Addendum No.: 4

Date of Addendum: June 17, 2020

Willard Diloreto Parking Garage
Paul Manafort Sr. Drive
New Britain, CT
CF – RC – 402

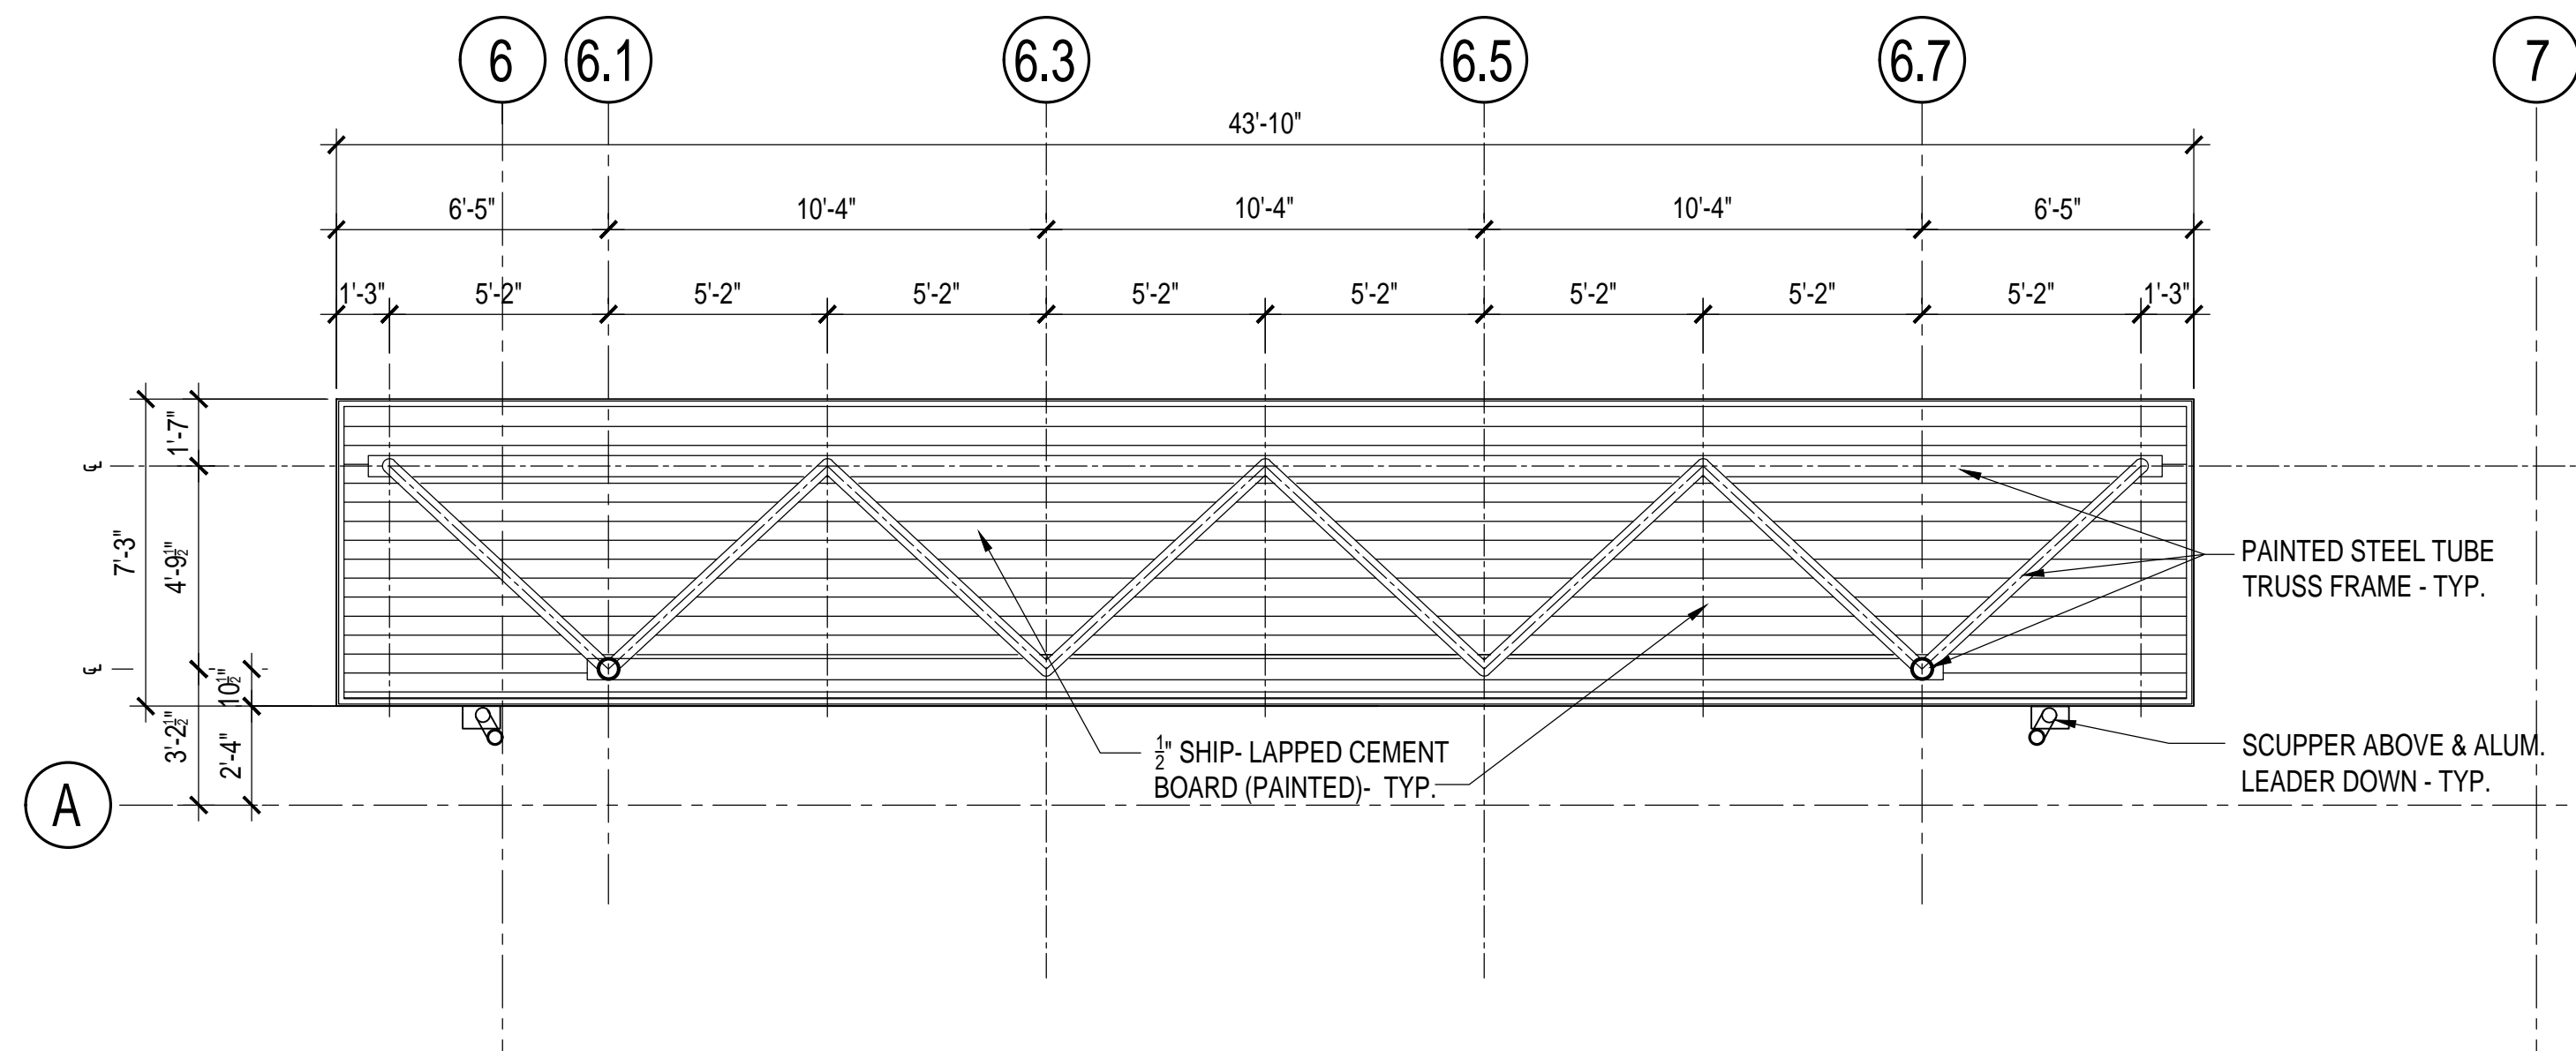
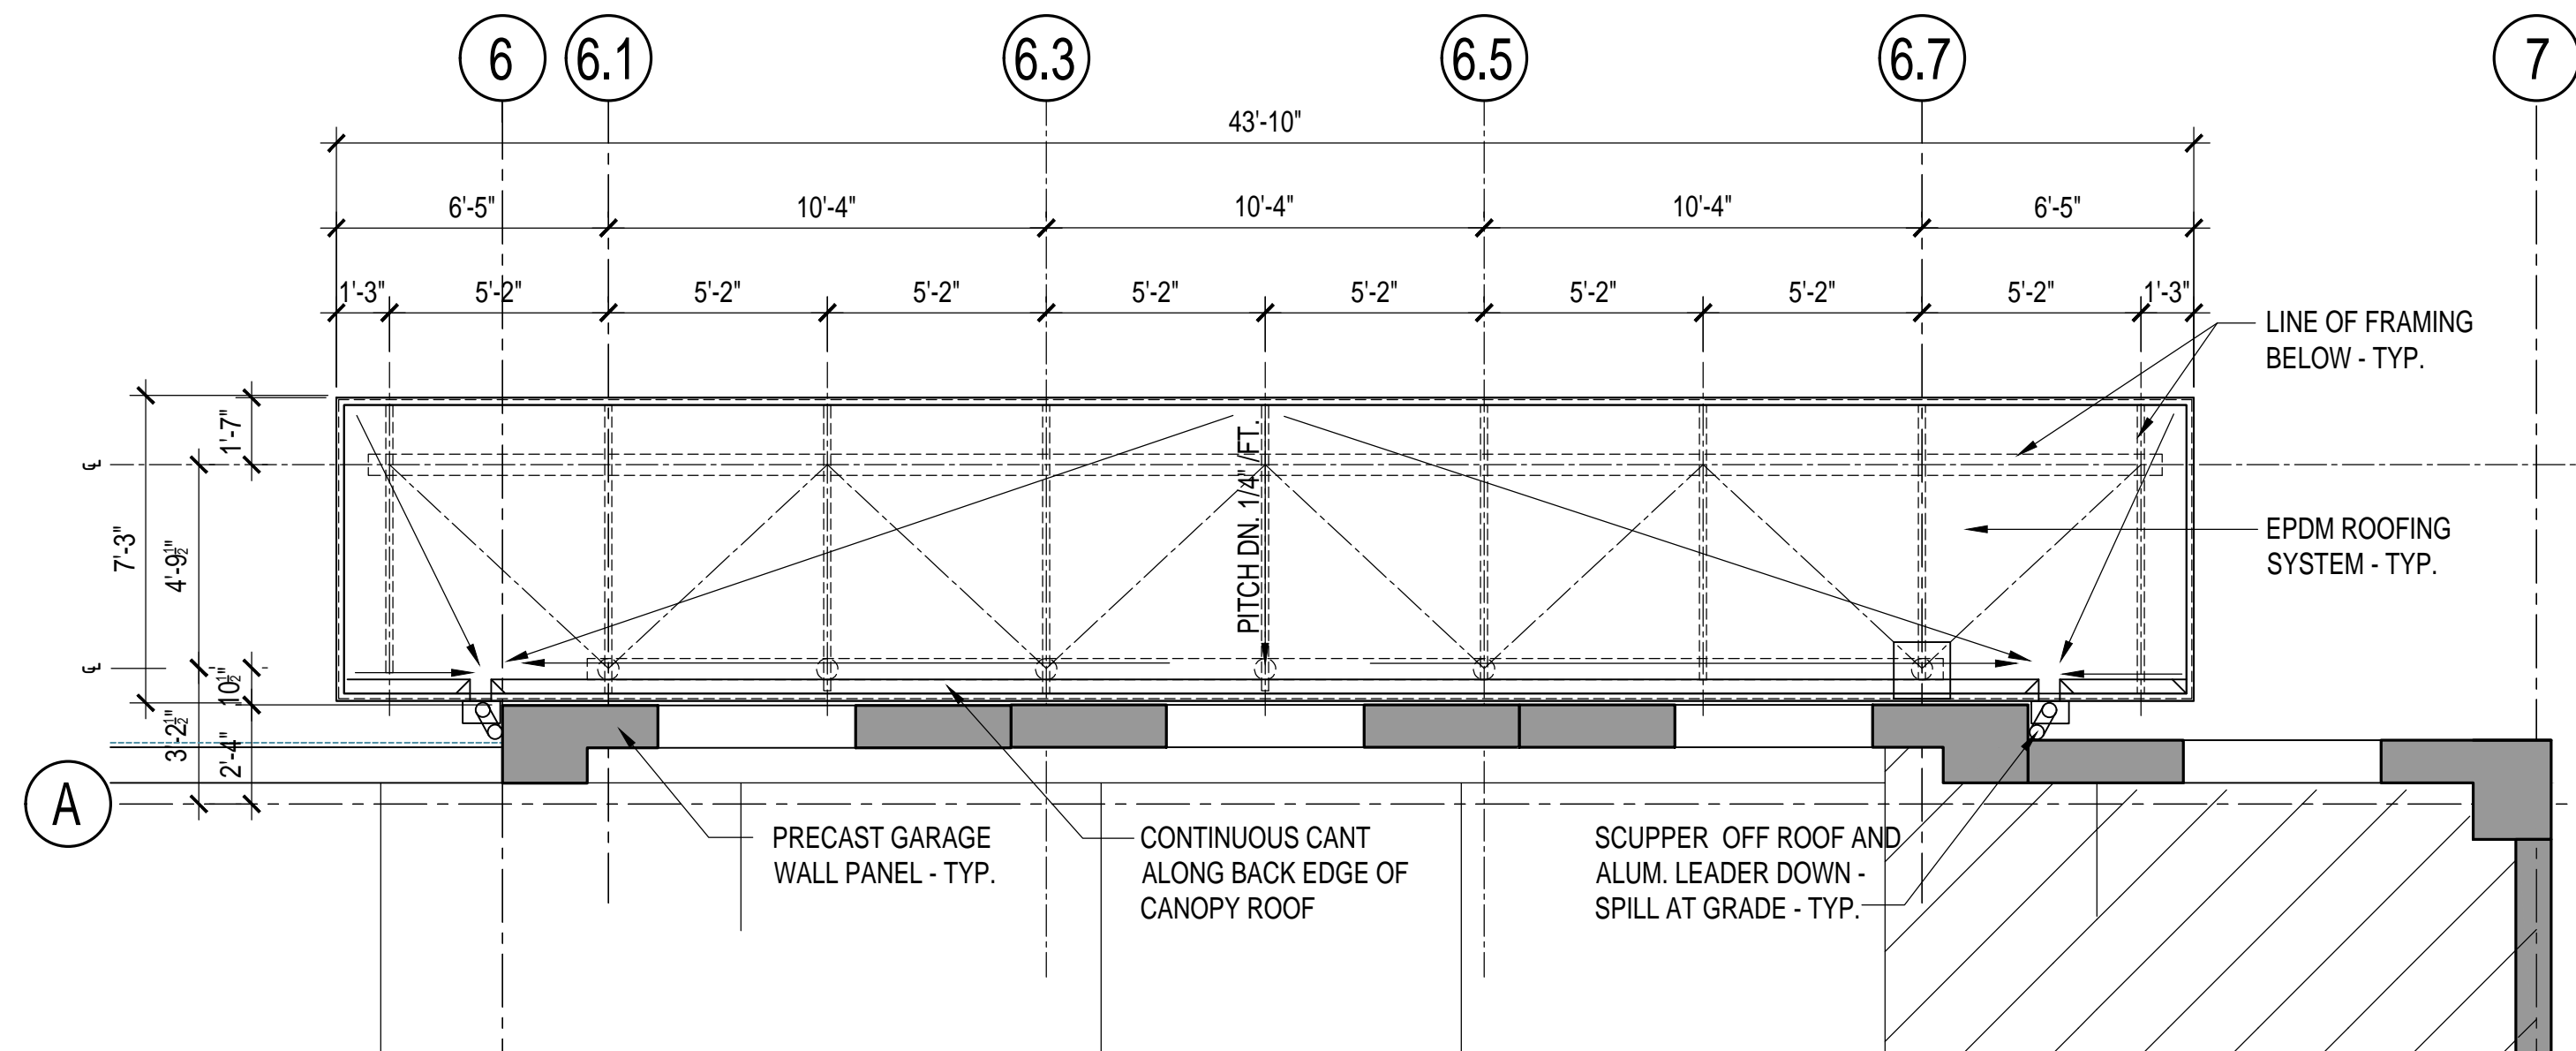
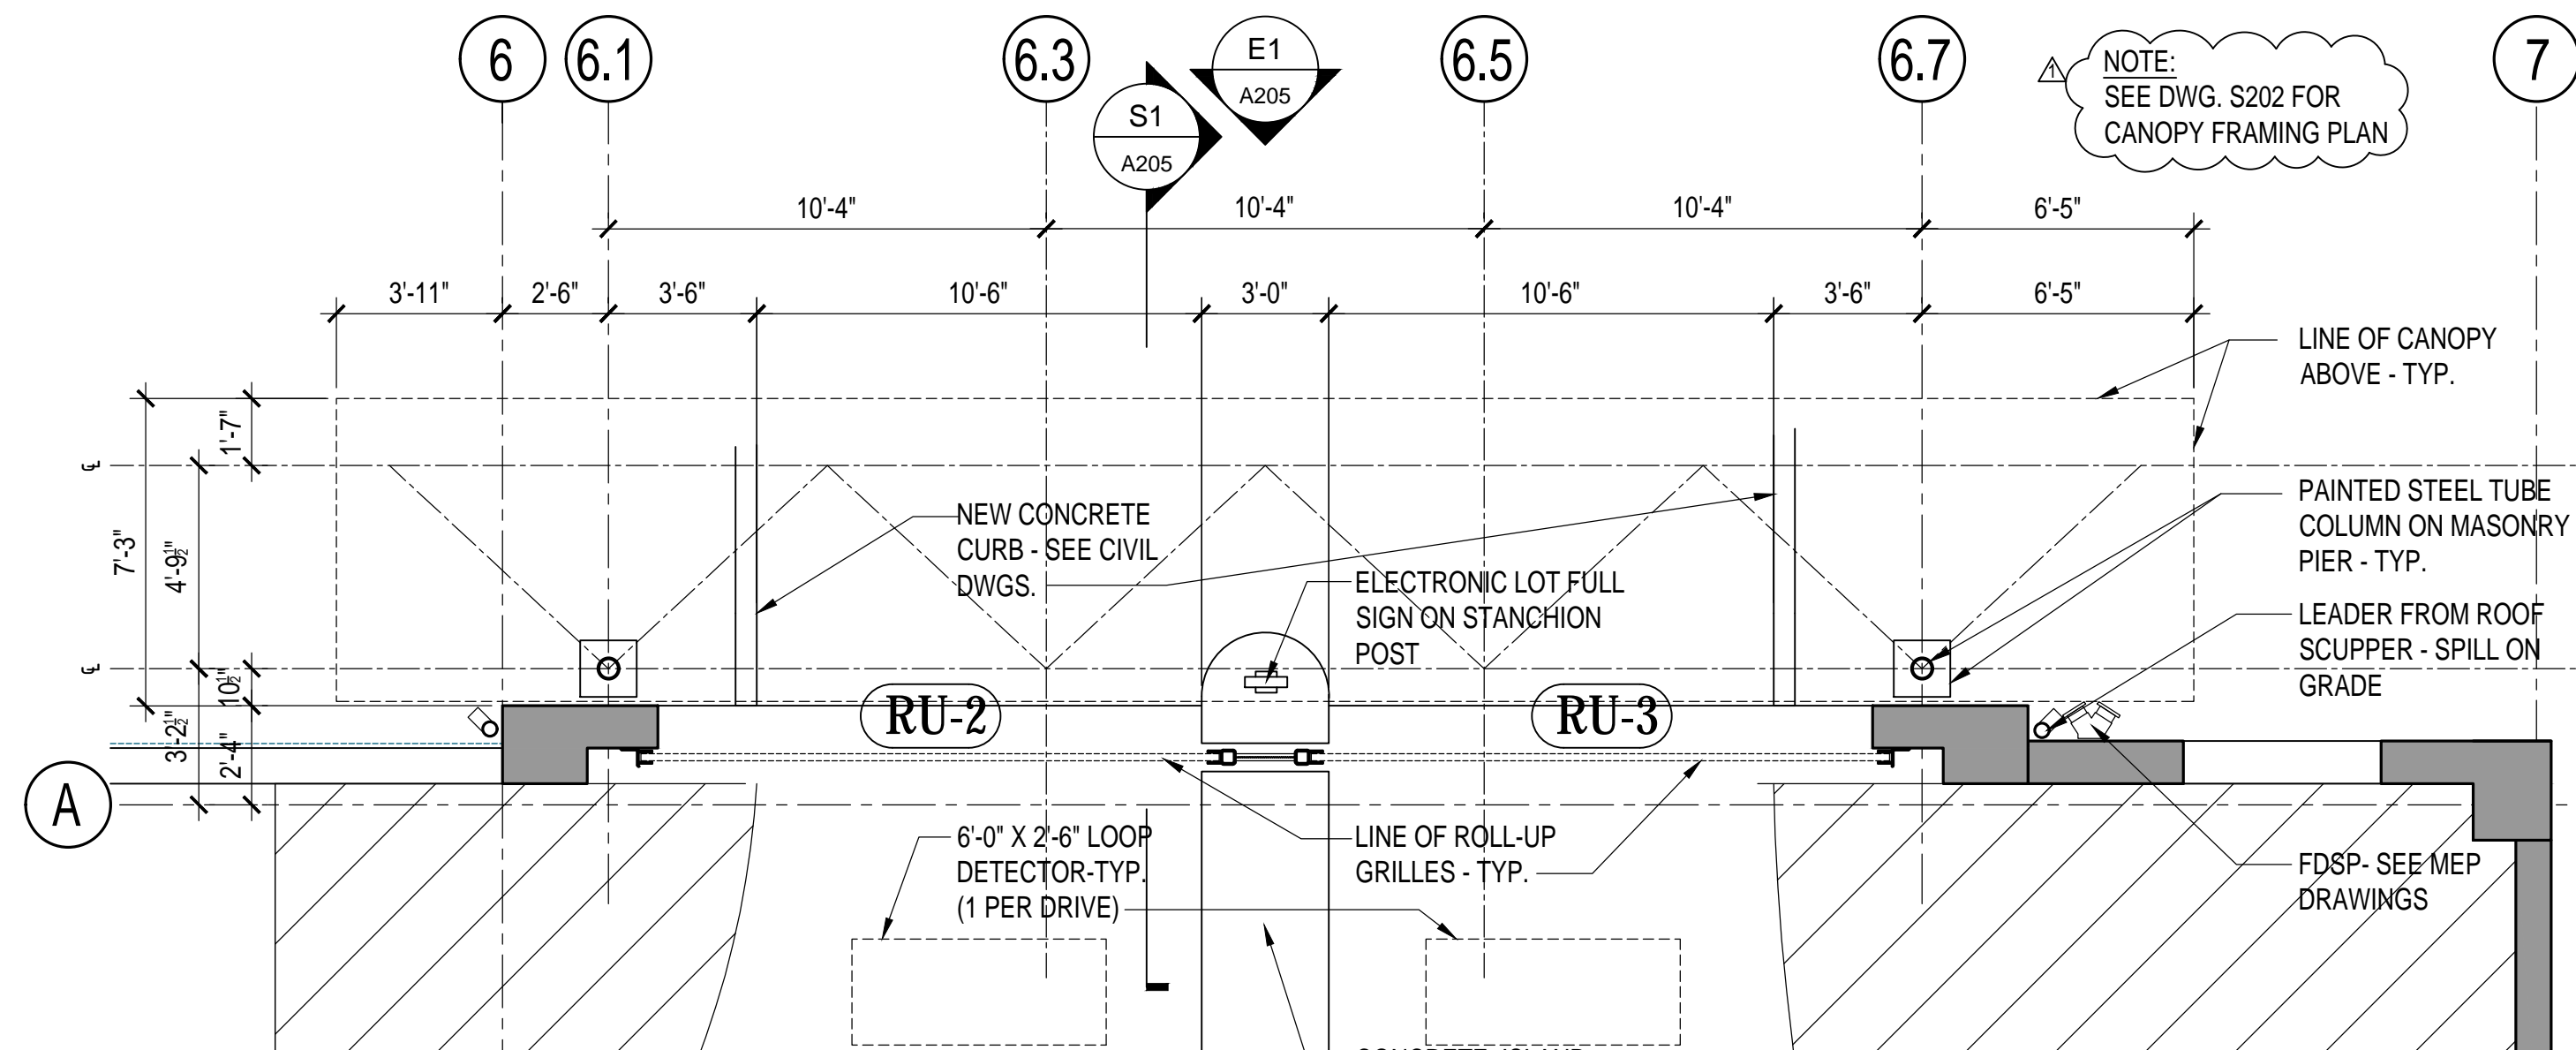
Question: Dwg A205. Please provide corresponding structural drawings and member sizes for canopy structure.

Answer: See revised drawing S202 with Canopy Framing structural details added.
